| FED. ROAD DIST. NO. | STATE | FED. AID PROJ. NO. | FISCAL YEAR | SHEET NO. | TOTAL SHEETS |
|---------------------|-------|--------------------|-------------|-----------|--------------|
| HAWAII              | HAW.  | NH-083-1 (43)      | 2001        | ADD.99    | 121          |

| <b>CONSTRUCTION NOTES</b><br><b>ELECTRICAL LEGEND</b>                                                                 |                      |
| KAMEHAMEHA HIGHWAY RESURFACING<br>Waiahole Valley Road to Crouching Lion Inn<br>Federal Aid Project No. NH-083-1 (43) |                      |
| SHEET No. E-1 OF 20 SHEETS                                                                                            |                      |

3 DUCT SECTION  
NOT TO SCALE

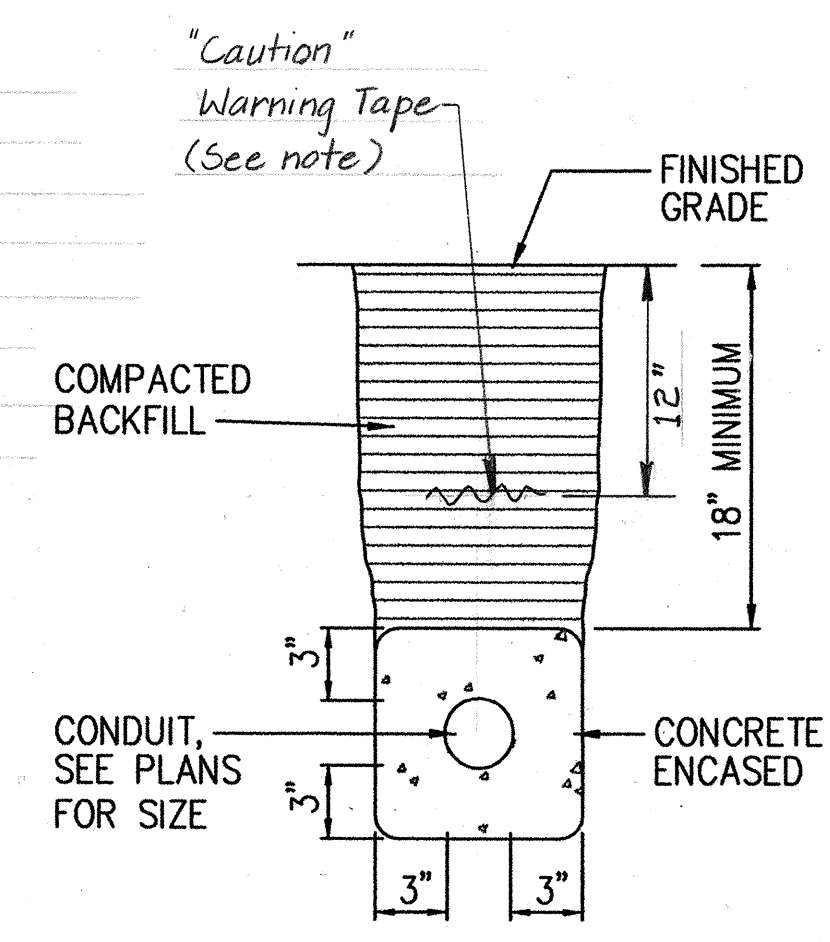
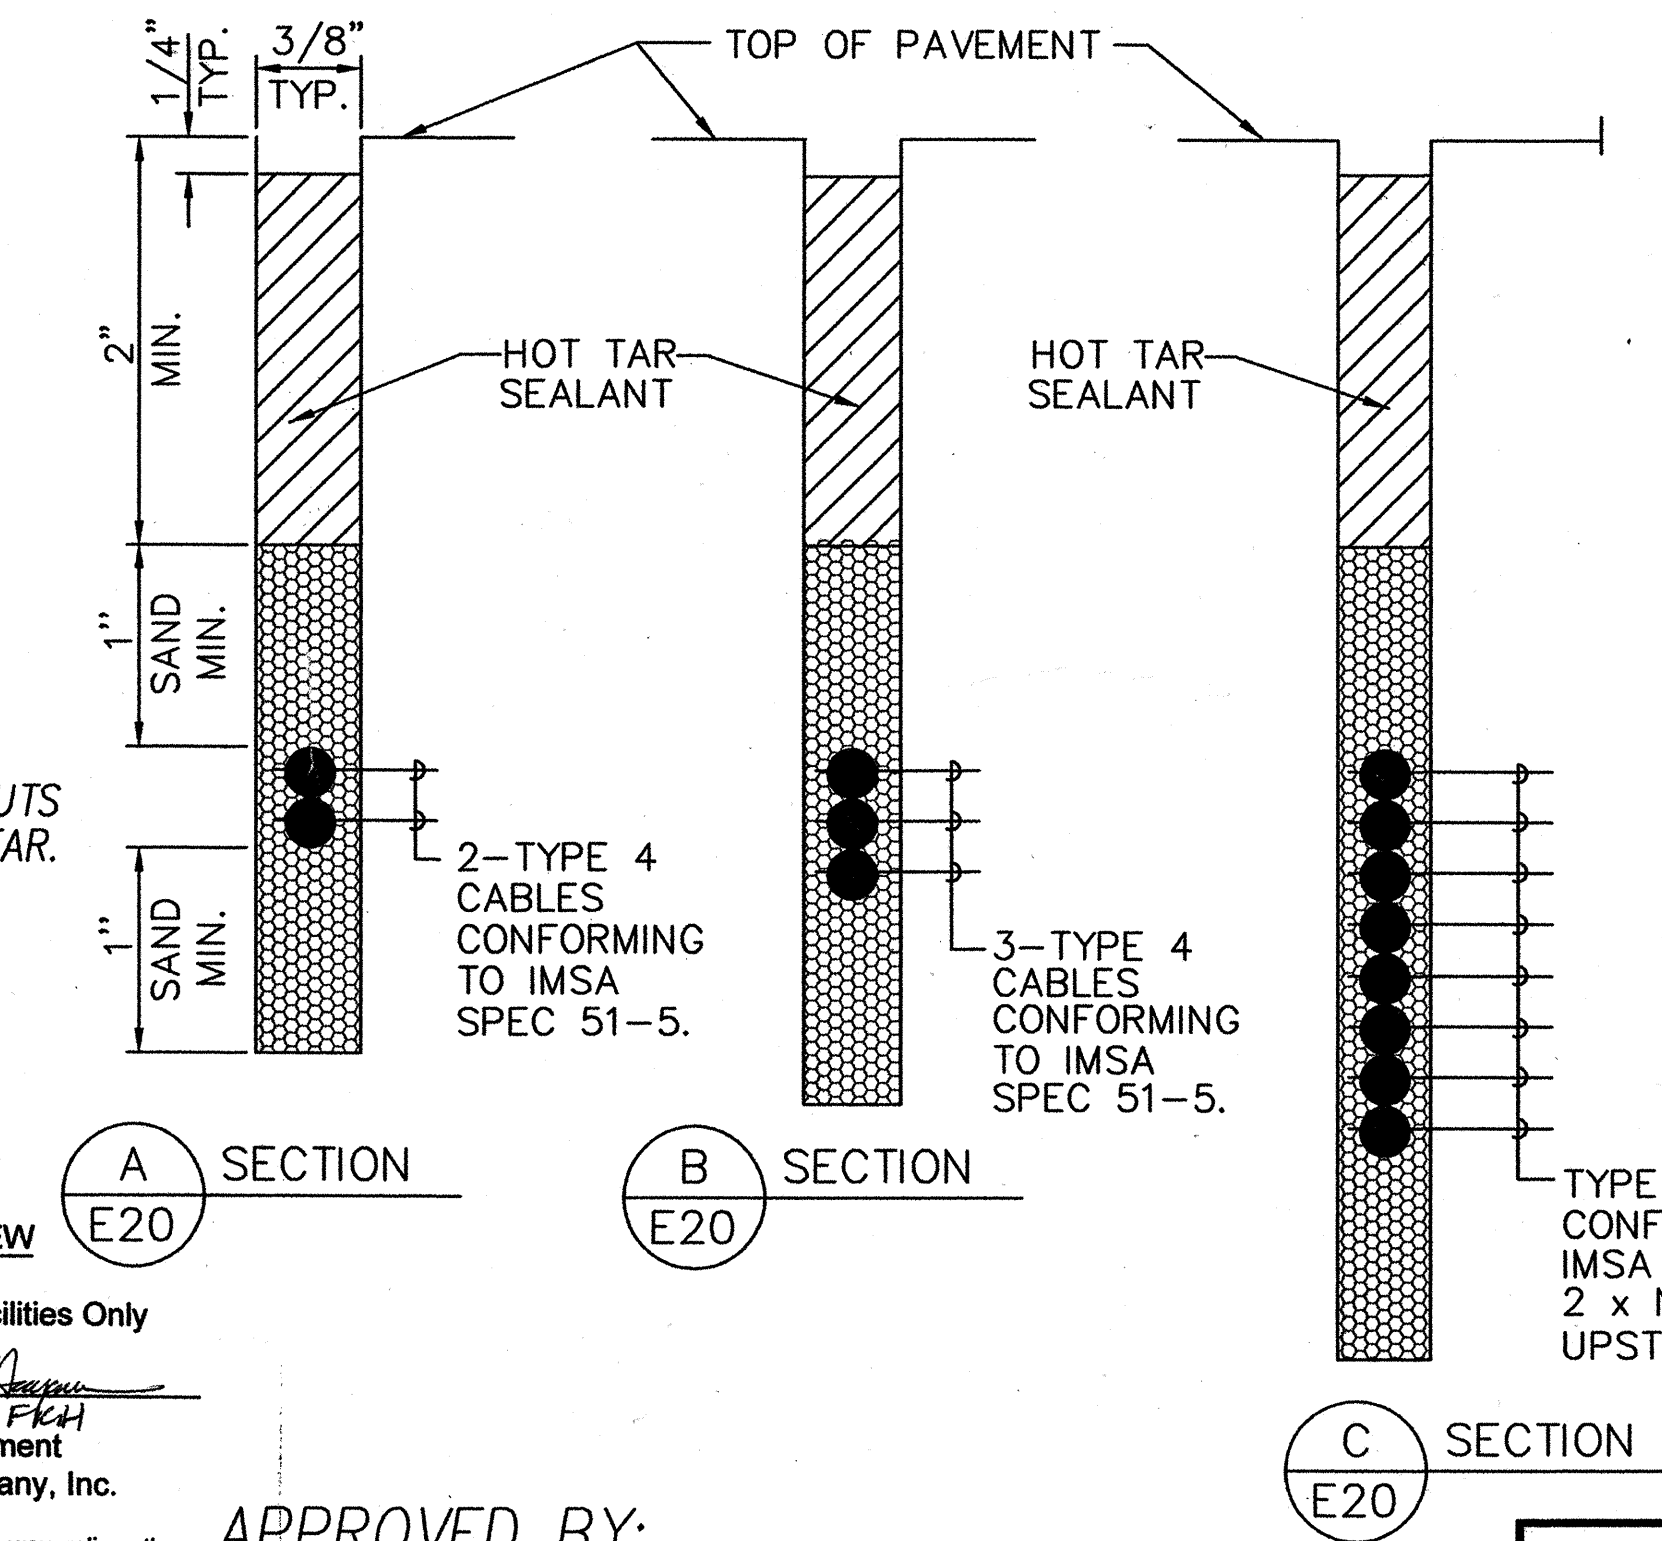
| 2/4/02 | Added Warning Tape to Duct Section Per Addendum No. 2 |

NOTE:  
The Metal Detectable Warning Tape shall be a minimum of 5 mils thick and 4" wide with a Continuous Metallic Backing and Corrosion Resistant 1± mil thick Foil Core. The message on the tape shall read, "Caution - State Traffic Signal and/or Hwy Lighting Buried Below," utilizing 2-inch Series "C" Black Lettering. The message will be repeated with a 36-inch spacing.
